# Lake Fordyce Dam Seepage Mitigation Project (Lake Fordyce, Nevada County)

**ADDENDUM to the  
Initial Study and Mitigated Negative Declaration and  
Previous Addendum for the Lake Fordyce Dam  
Seepage Mitigation Project**

**SCH No. 2020090506**

**May 2024**

**Figure 2-1. Work Area Components**

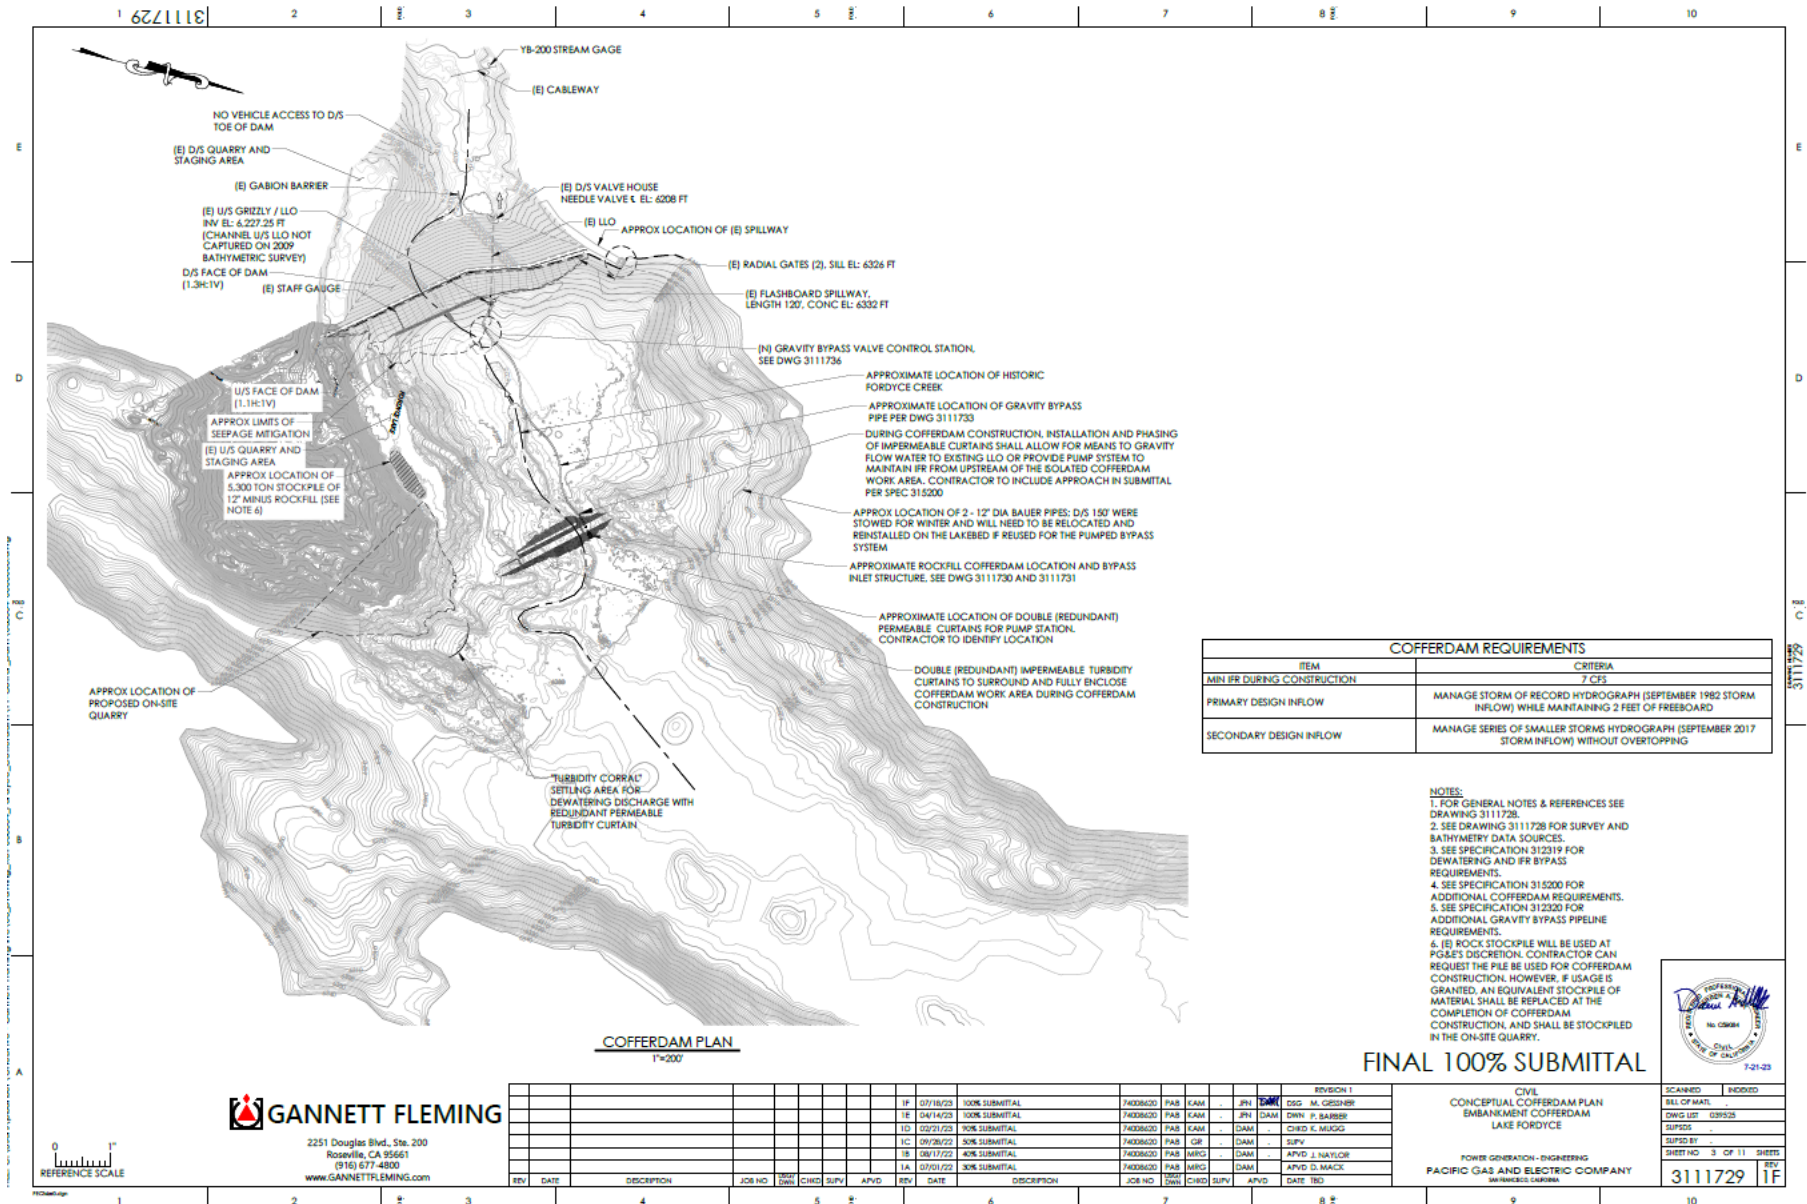
**On-Site Rock Quarrying:** One or two local quarry areas would be developed to source rock for the cofferdam embankment and associated rock buttress. This includes a preferred quarry area and alternate quarry area (Figure 2-). The preferred quarry area is near the abandoned upstream quarry, which was used to source rock for Lake Fordyce Dam. If the preferred upstream quarry area cannot produce enough of the main embankment material, or the larger buttress rockfill, then the alternate quarry area near the existing downstream quarry would be developed. Compared to the alternate quarry location, the preferred quarry location is farther from the dam, reducing the potential risk of damage to the dam from blasting operations; and is closer to the cofferdam location, reducing on-site hauling distance and time.

**Modified Project Area:** Figure 2- depicts the Proposed Project Area in the vicinity of the dam. The addition of the quarry locations has increased the total Proposed Project Area by approximately 2.3 acres. The change in cofferdam design is contained in the original Lake Fordyce Dam Seepage Mitigation Project Area described in the 2020 IS/MND and 2021 Addendum. The Proposed Project Area along the access road is unchanged by the proposed modifications.

Figure 2-2. Modified Cofferdam Details

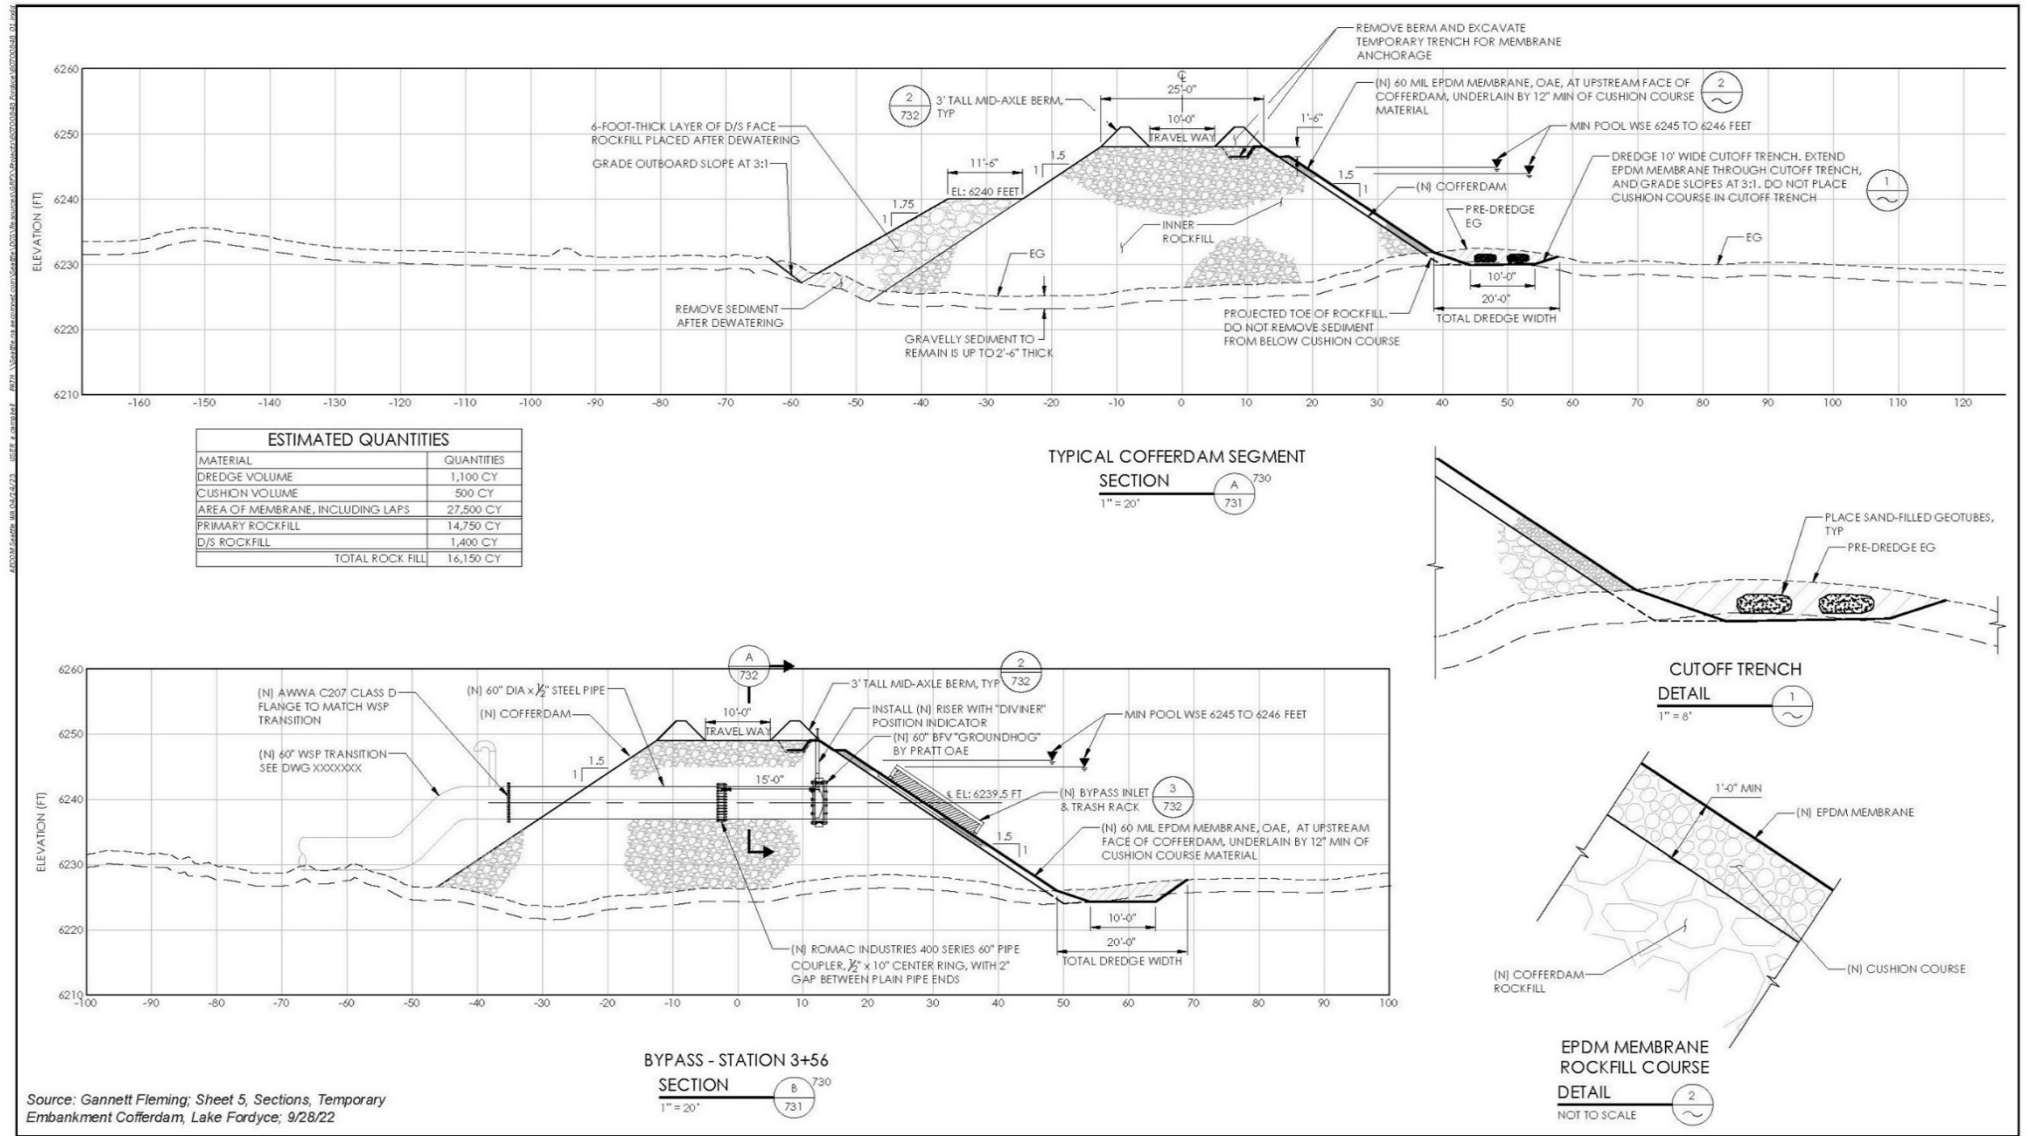
**Cofferdam:** The Proposed Project would no longer use a bin-wall cofferdam, as previously proposed in the 2020 IS/MND (as carried forward and modified in the 2021 Addendum to include additional dredging and associated changes), and instead would use a trapezoidal rockfill cofferdam in the same location and along the same alignment as the previous bin-wall cofferdam with a slightly larger bottom footprint (Figure 2- and Figure 2-2). The rockfill cofferdam would be approximately 25 feet wide at the crest (the same as the previous bin-wall design), 23 feet tall, and span an approximate length of 450 feet across the reservoir. The bottom footprint of the proposed rockfill cofferdam would be approximately one acre, approximately 0.47 acre larger than the prior bin-wall cofferdam design, due to the trapezoidal shape of the rockfill cofferdam (see Table 2-12).

The upstream face of the cofferdam would be covered with a membrane liner to limit leakage through the cofferdam. The membrane would be placed on the surface of the lakebed and held in place by crushed rock or other aggregate ballast, sand tubes, or rock filled sacks. Installation of the membrane would require dredging for a cutoff trench in the area immediately upstream of the cofferdam. The cutoff trench would have an approximate width of 20 feet and extend along the full length of the cofferdam, approximately 450 feet. Mechanical dredging and/or limited hydraulic suction dredging would be used to remove an additional 1,100 cubic yards of mud, silt, sand, and gravel for the cutoff trench.

Compared to the design analyzed in the 2021 Addendum, the Proposed Project would reduce the excavation volume for the cofferdam by approximately 900 cubic yards and the excavation area by approximately 7,400 square feet (0.17 acre). After the modified project is complete, rock from the cofferdam would become permanent fill in Lake Fordyce, as was discussed for rockfill associated with the bin-wall cofferdam design in the 2020 IS/MND. As indicated in Table 2-2, the permanent fill volume for the cofferdam would increase to 17,000 cubic yards, an increase of 2,800 cubic yards. The total permanent fill volume would increase by approximately 4,300 cubic yards and the permanent fill area would increase by 21,600 square feet (0.5 acre) due to the wider base for the rockfill cofferdam and downstream rock buttress. The Proposed Project would also add additional excavation volume and area for the on-site quarry(ies).

To provide a positive cutoff at the upstream toe of the cofferdam, the lake bottom along the cofferdam footprint would be mechanically dredged to stable bedrock using an excavator, clamshell dredge, or similar equipment. Approximately 1,100 cubic yards of additional surficial mud, sand, and gravel would be removed from the lakebed for the positive cutoff at the upstream toe of the cofferdam (3,000 cubic yards already removed during Construction Year One). The dredged material would consist of a relatively thin layer of surficial silt, and the remainder of the material would consist primarily of sand and gravel. Mechanically dredged material would be loaded into a material barge, taken to the shore, then loaded into haul or dump trucks and placed at the staging area downstream of the dam. If needed, mechanical dredging may be supplemented with limited hydraulic (suction) dredging. If limited hydraulic dredging is needed, this dredged material would be moved to the shore via a pipe, deposited into an area contained with berms or similar containment, and then loaded into haul or dump trucks and placed at the staging area downstream of the dam. Dredged material placed in the staging area would be confined and stabilized to eliminate any turbid runoff entering the lake or Fordyce Creek.<sup>3</sup>

**Figure 3-3. Previously Assessed Project Area, Cultural Sites, and New Quarry Areas**

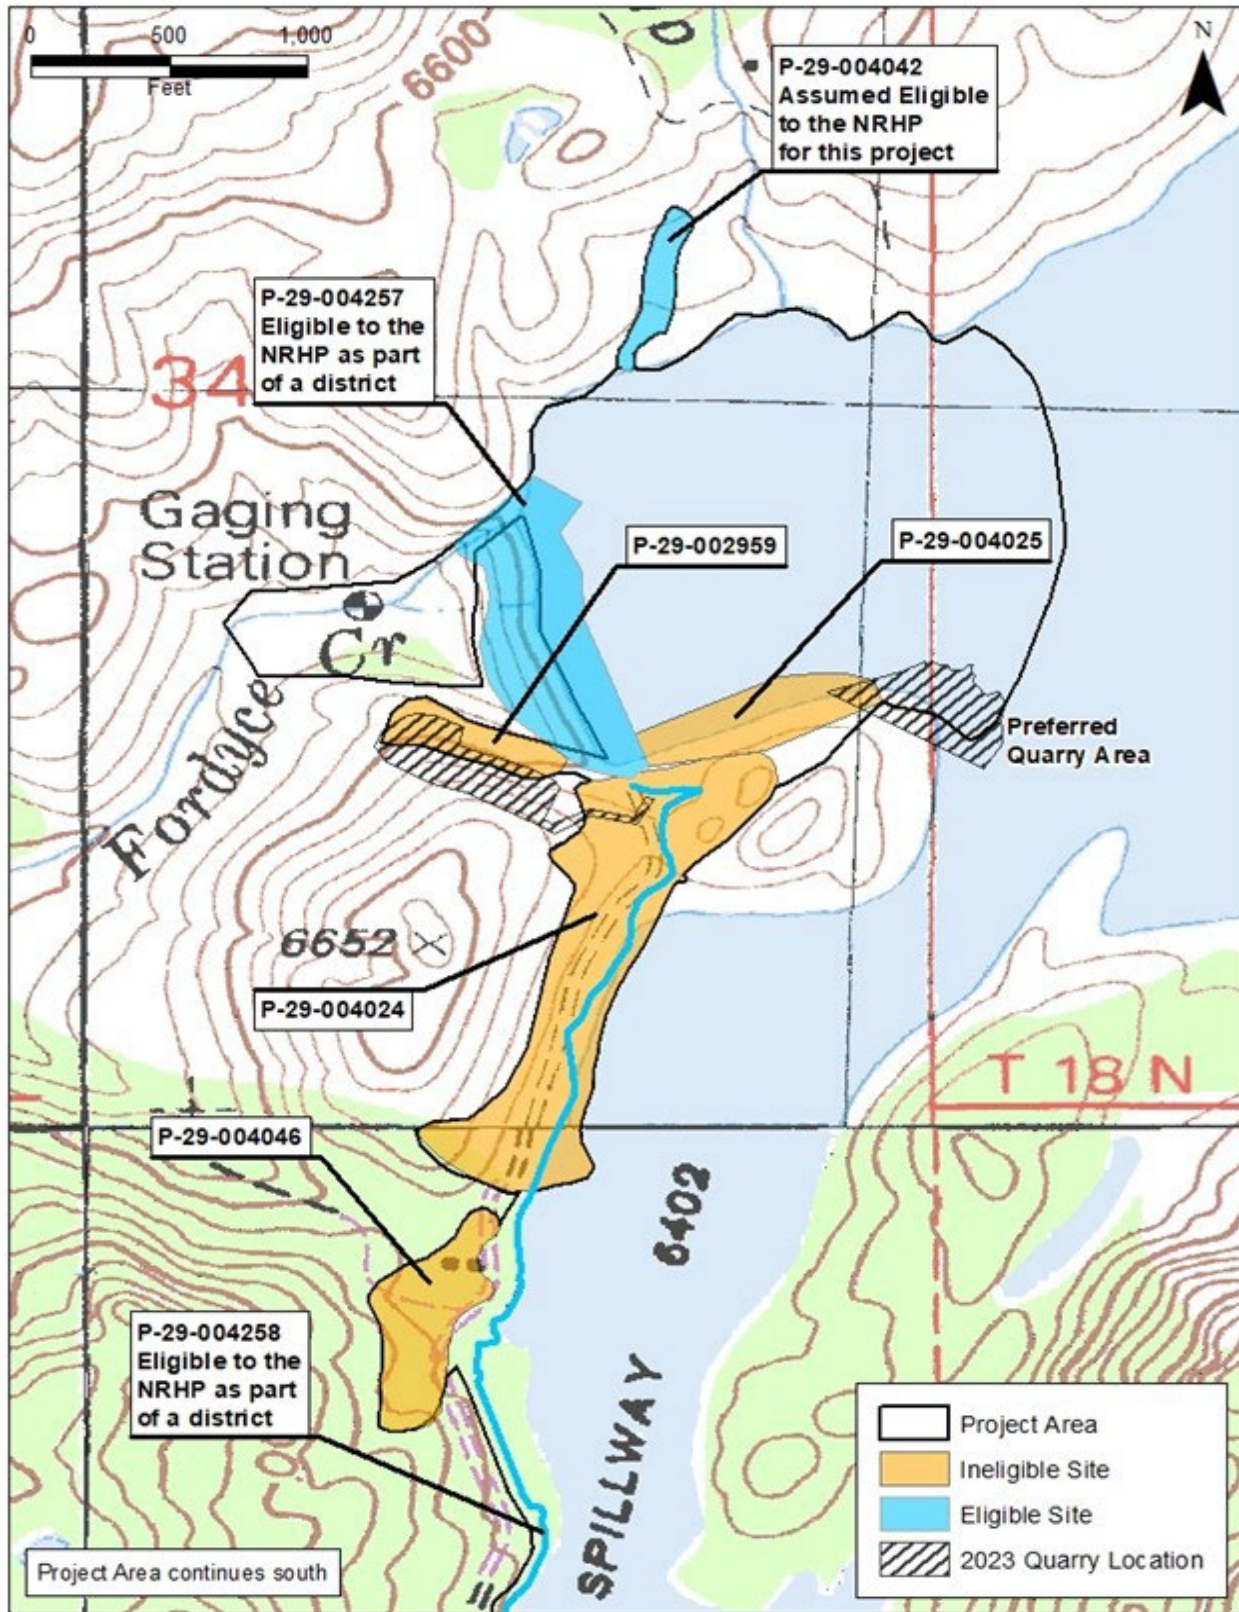
The 2020 IS/MND identified three potential cultural resource areas that overlap with the new quarry areas included in the Proposed Project, but these potential resource areas were determined to be ineligible for listing in the National Register of Historic Places

The eastern segment of the preferred quarry area and southern segment of the alternate quarry area are just outside the study area evaluated in the 2020 IS/MND, as shown in Figure 3-3. The portion of the preferred quarry area that was not submerged by Lake Fordyce was surveyed in 2011, and no cultural resources were identified (Information Center Study No. 10561). The northern portion of the alternate quarry area was surveyed for cultural resources in 2011, by Study No. 10561, and in 2020, as part of the original Lake Fordyce Dam Seepage Mitigation Project; no cultural resources were identified. Although the Proposed Project includes additional quarry areas outside of the study area considered in the 2020 IS/MND and 2021 Addendum, the absence of recorded cultural resources in the newly added areas and the non-depositional, steep terrain, and results from neighboring investigations indicate that there is a low probability of encountering cultural resources in these areas.

Sites eligible or assumed eligible for NRHP listing within the original Lake Fordyce Dam Seepage Mitigation Project and Proposed Project Area are also depicted in Figure 3-3 and were considered in the 2020 IS/MND. The 2020 IS/MND determined that the original Lake Fordyce Dam Seepage Mitigation Project would result in no adverse impact to eligible sites P-29-004257 (Lake Fordyce Dam) and P-29-004258 (Lake Fordyce Road), and less than significant impacts to assumed eligible site P-29-004042 (Abandoned Road Grade, Mining Features, and Refuse) with implementation of MM CUL-1. Similar to the original Lake Fordyce Dam Seepage Mitigation Project and analysis in the 2020 IS/MND, the Proposed Project would result in functional improvements to Lake Fordyce Dam and Lake Fordyce Road and would not adversely affect these sites. The Proposed Project would not affect P-29-004042 (Abandoned Road Grade, Mining Features, and Refuse), which occurs outside of the modified cofferdam design area. Additionally, MM CUL-1 (Procedures to Avoid Impacts on Archeological Resources) remains applicable and required.
